Norwich to Tilbury

Document: 9.11 Proposed Change Application 1: Addendum to
Environmental Statement - Change Request 1 (Bulphan) (CA1)

Final Issue CA1

March 2026

Title:
Figure CR1.1 - DCO and proposed new Order Limits - Change Request 1

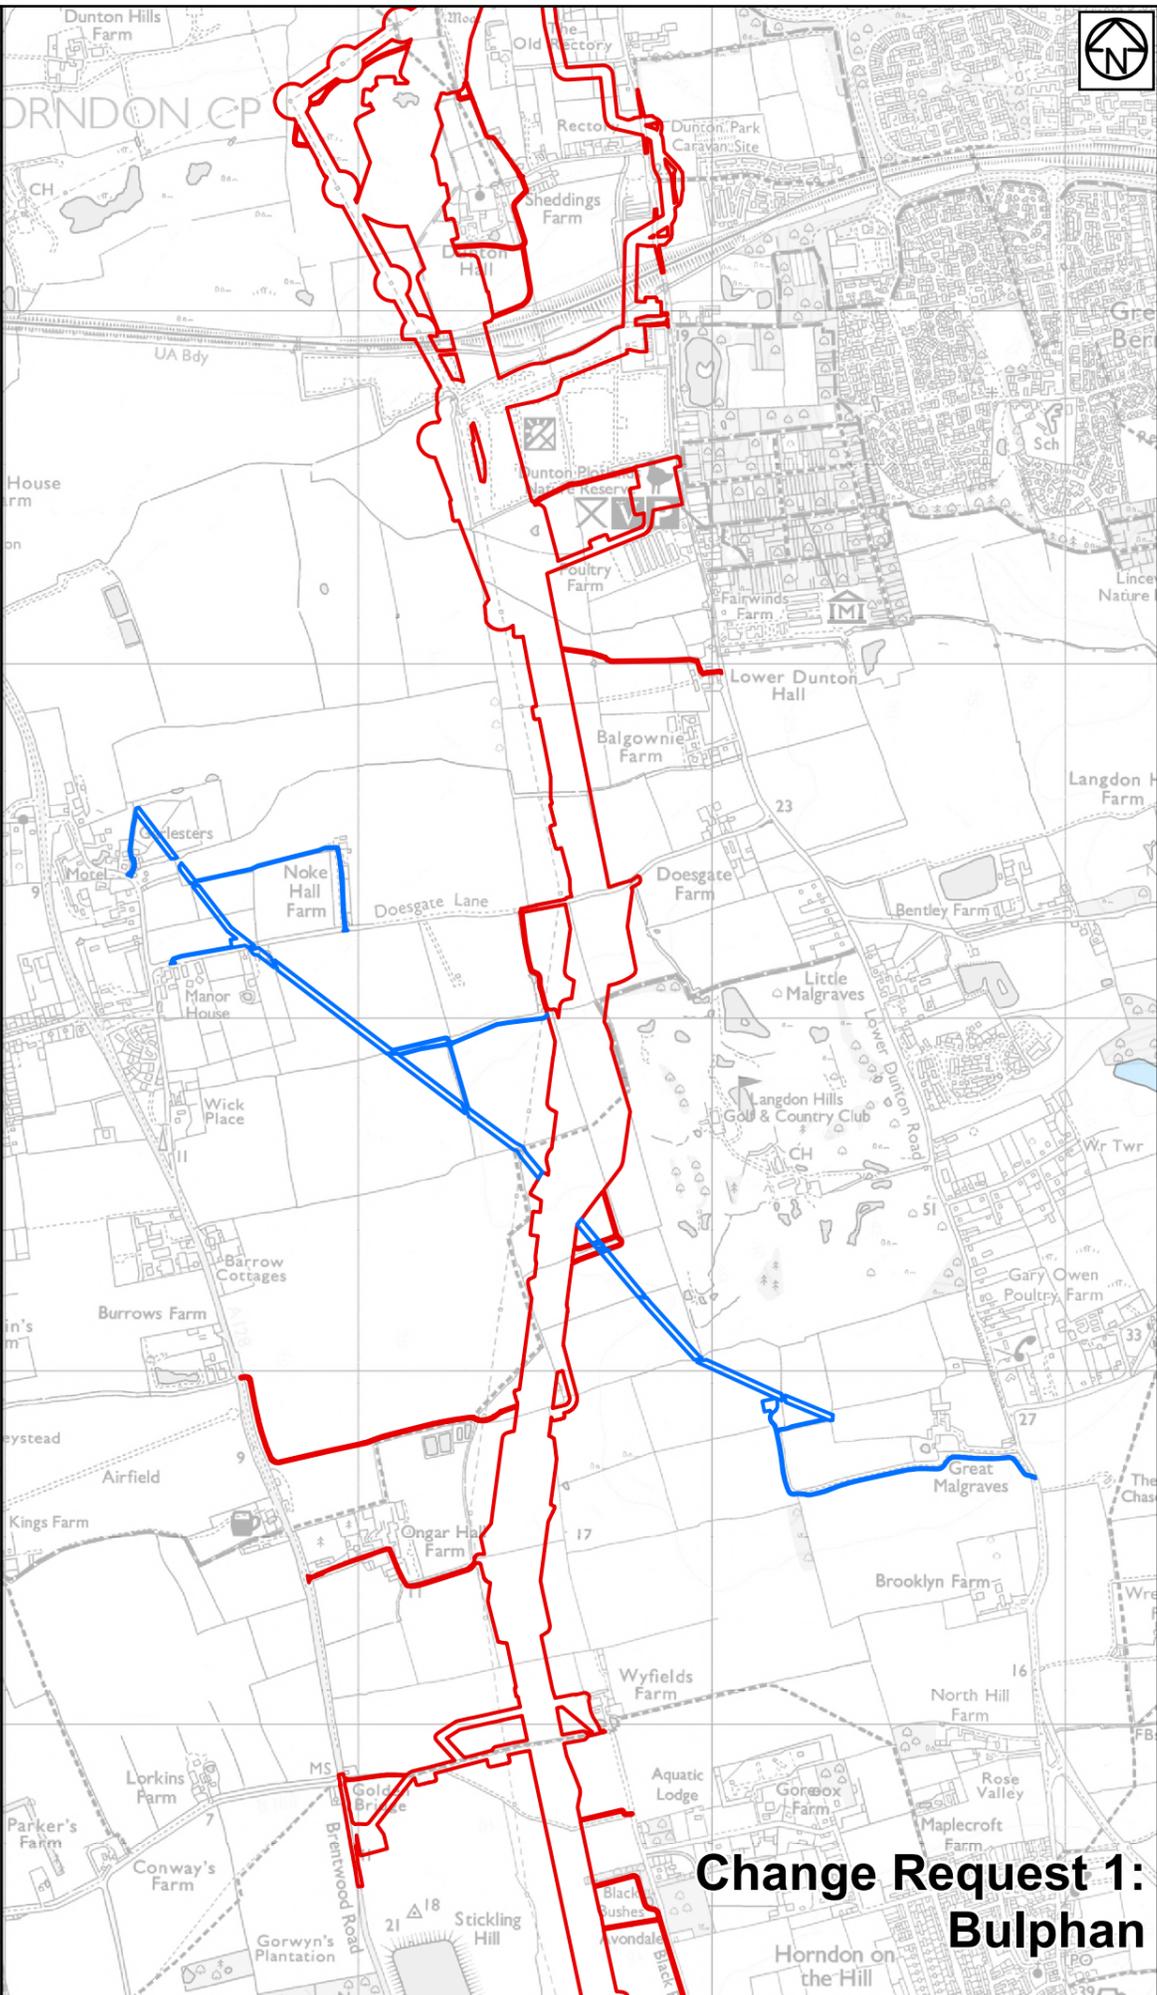
1.3.1 The Applicant is proposing an increase in the Order Limits to facilitate works required for the protection of the existing Thames to Buncefield Multifuel Pipeline, west of Langdon Hills Golf Club (see Figures CR1.1, CR1.2 and CR1.3 in Appendix D). This proposed design change responds to feedback concerning accelerated corrosion on existing buried metallic services received from the British Pipeline Agency (BPA) Ltd who act as the agent for the owner, United Kingdom Oil Pipelines (UKOP) Limited.

Title:
 Figure CR1.4 - Ecology and Biodiversity - UK Habitat Survey Results Revision (Change Request 1) Section H

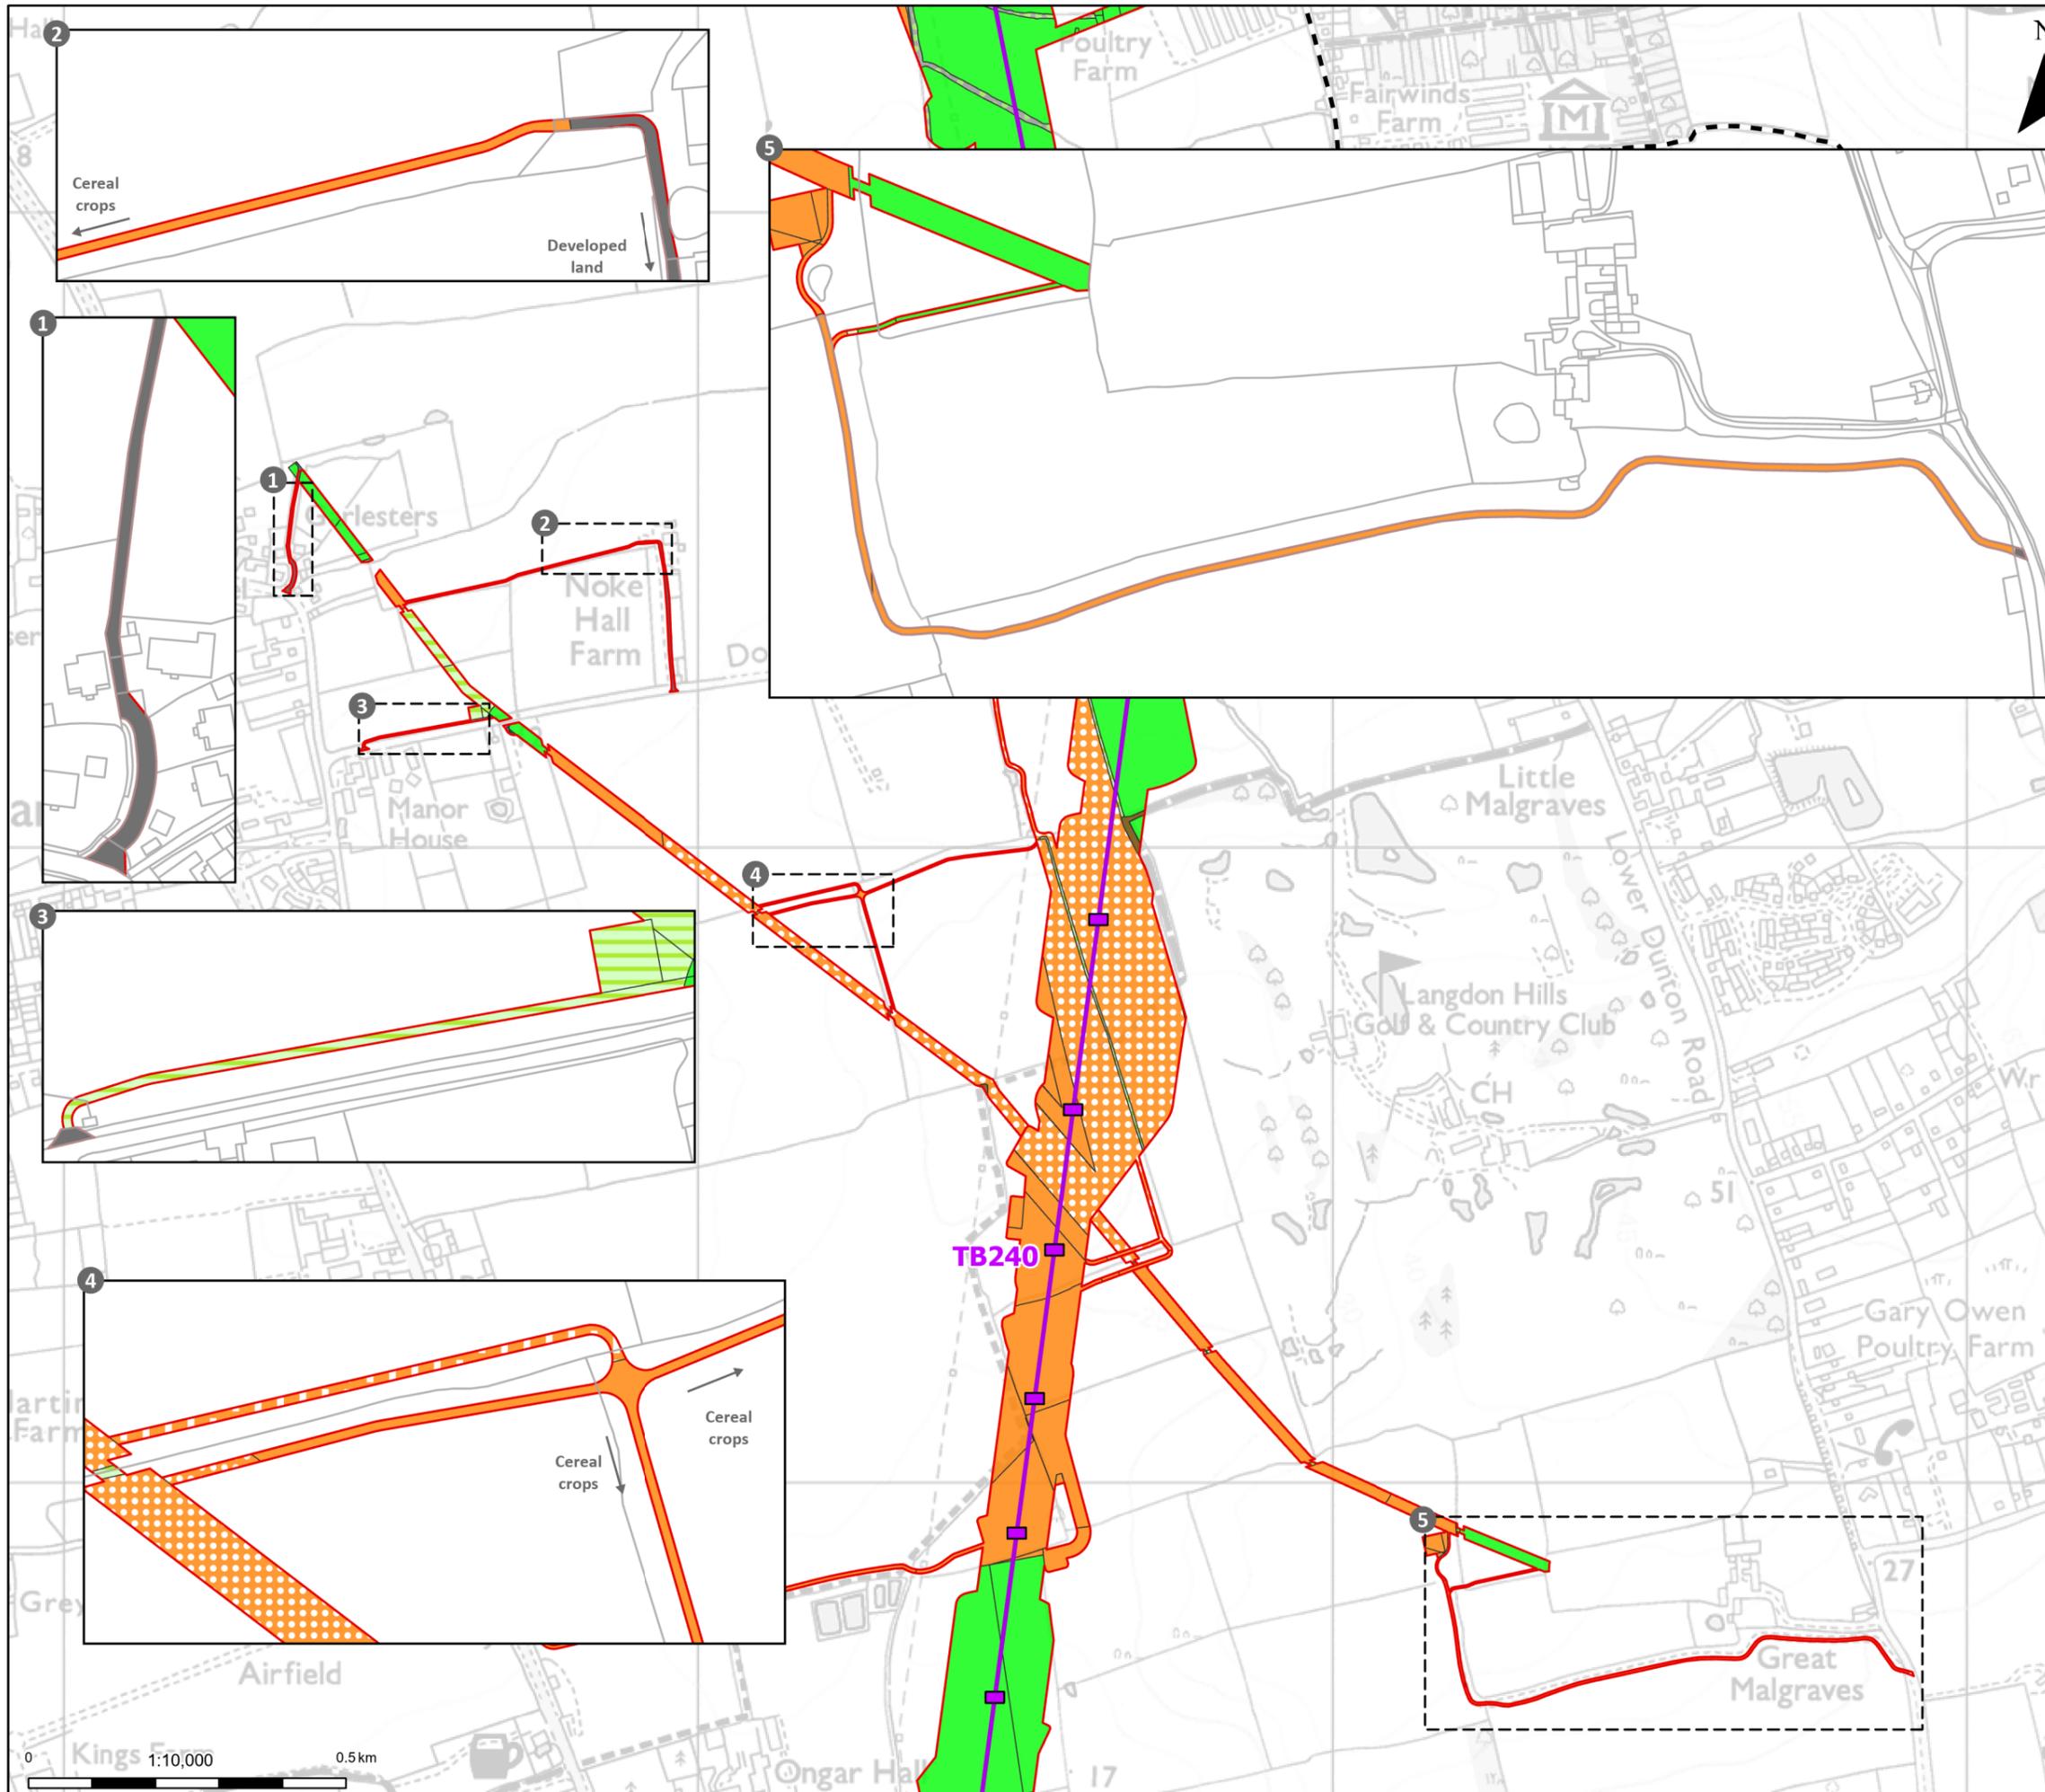
AS-026	6.8 Environmental Statement Chapter 8 - Ecology and Biodiversity Chapter 8	<p>A walkover of the proposed design change area was undertaken in November 2025. Survey results are presented in Appendix A. The proposed design change would slightly increase the amount of habitat temporarily impacted in the short-term, because of the required excavation works. However, habitats along the existing pipeline are arable and of low ecological value, as presented on Figure CR1.4 - Ecology and Biodiversity - UK Habitat Survey Results Revision and</p>

Title:
Figure CR1.5 - Ecology and Biodiversity - Linear Habitat Survey Results Revision (Change Request 1) Section H

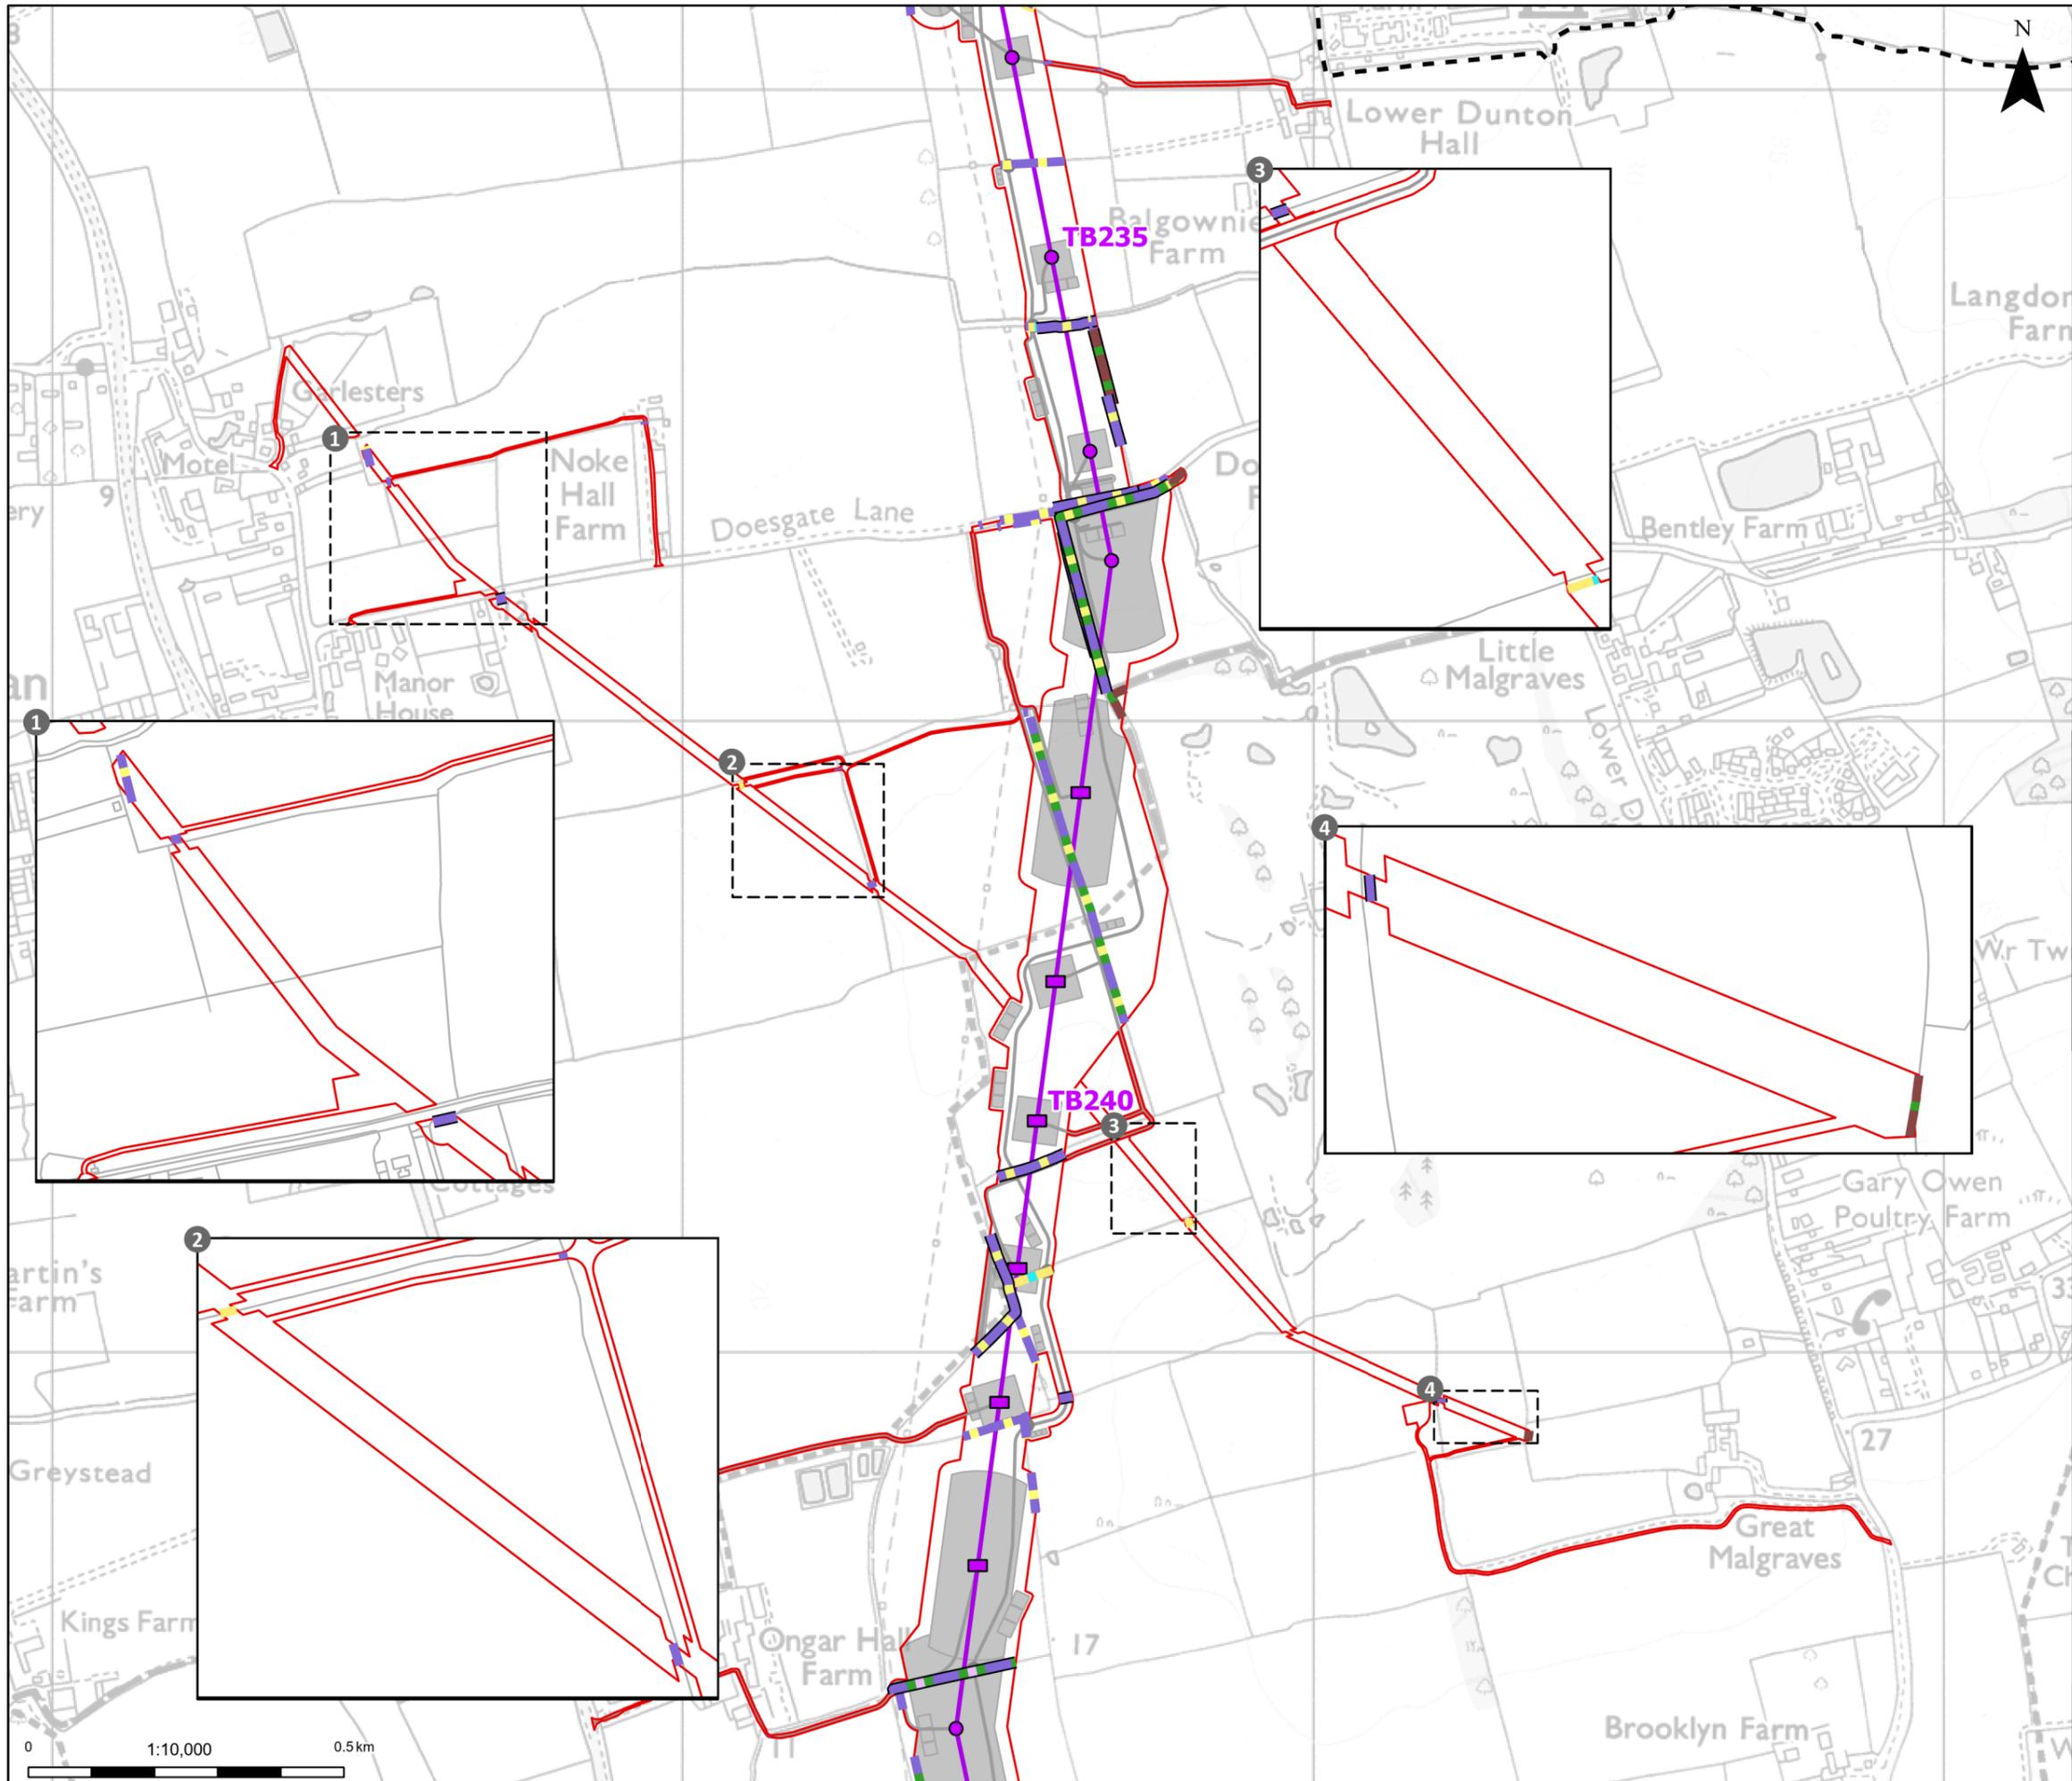
Application Document Reference	Relevant ES Chapter	Review of whether new or different likely significant environmental effects would arise as a result of the proposed design change
		<p>Figure CR1.5 - Ecology and Biodiversity - Linear Habitat Survey Results Revision in Appendix D. There would be no additional impacts to irreplaceable habitats or habitats of principal importance. Impacts to tree and hedgerows on field boundaries would be avoided as it is not proposed to excavate beneath, or within the root protection zones of these features. The proposed test posts at field boundaries as part of the design would not be expected to result in likely significant effects.</p> <p>Following implementation of mitigation measures set out in 7.4 Outline Landscape and Ecological Management Plan (LEMP) [REP2-018] and 7.2 Outline CoCP [REP2-014], there would be no change to the type or significance of effect during construction or operation (and maintenance) on habitat features as presented within 6.8 Environmental Statement Chapter 8 - Ecology and Biodiversity [AS-026]. The proposed design change would not cause significant impacts to any designated sites or protected species, given the distance from any designated feature and the small-scale and temporary nature of the works associated with the proposed design change. Overall, there would be no change to the type or significance of ecology and biodiversity effects during construction or operation (and maintenance) as a result of the proposed design change, when compared to 6.8 Environmental Statement Chapter 8 - Ecology and Biodiversity [AS-026].</p>
